URGENT FIELD SAFETY NOTICE

FSCA Reference: 1280465 – SPRINTER CART (XL) – Missing 'Pushing prohibited' label

Affected Product: INFUSION POLE (Mat. 701033599)
SPRINTER CART (Mat. 701033456)
SPRINTER CART XL (Mat. 701046022)
SPRINTER CART (Mat. 701047813)
SPRINTER CART XL (Mat. 701054184)

Figure 1: Figure showing Sprinter Cart system with Infusion Pole and indicating position of 'Pushing prohibited' label (see red marking)

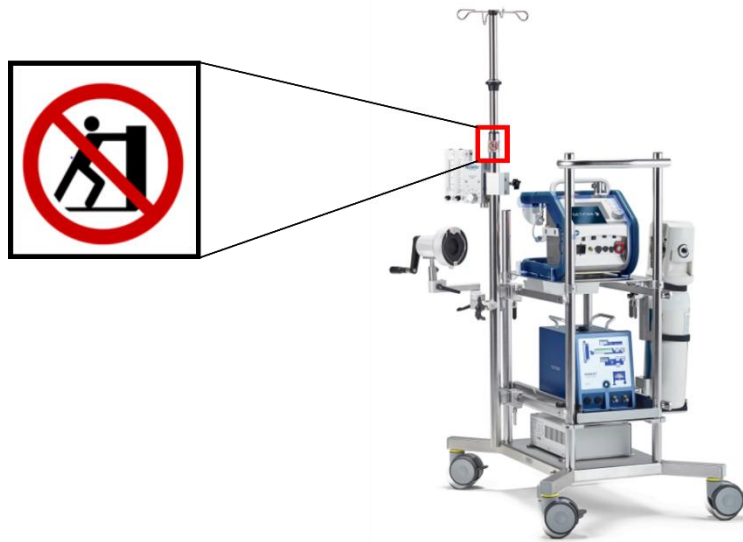
According to IEC 60601-1:2005+AMD1:2012+AMD2:2020, clause 9.4.2.3 'Instability from horizontal and vertical forces', if an equipment overbalances when being pushed/ leaned on/ etc. with 15% of its weight, the medical electrical equipment shall be marked with a clearly legible warning, e.g., safety sign according to ISO 7010-P017 (Figure 1).

Starting April 21, 2021, MCP implemented a safety sign on newly produced INFUSION POLES but did not correct INFUSION POLES manufactured before this date. Therefore, all INFUSION POLES manufactured before April 21, 2021, are affected by this issue.

- Verify presence of 'Pushing prohibited' label on each INFUSION POLE of SPRINTER CART/ SPRINTER CART XL **during next service visit**
- If not present, affix 'Pushing prohibited' label to INFUSION POLE of SPRINTER CART/ SPRINTER CART XL **during next service visit**
